Product Change Notice

Sub: 89 Series Resistors Dimensional Changes
Effective date: 1 August 2015

Old:

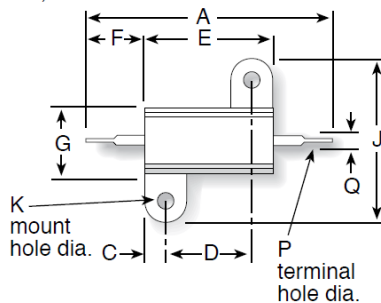
Ohmite announces dimensional changes to the 89 series of resistors. These changes are reflected on the mounting tabs and extrusion profiles. Foot design changes are from the (Old) rounded foot design to a (New) squared design. The changes are also seen in the extrusion profile. These changes have no effect on Fit, Form or Function of the parts. All new parts can be mounted in existing applications with no modifications. Part numbering will not change. Old and New dimensions are listed below for reference and are not to scale.
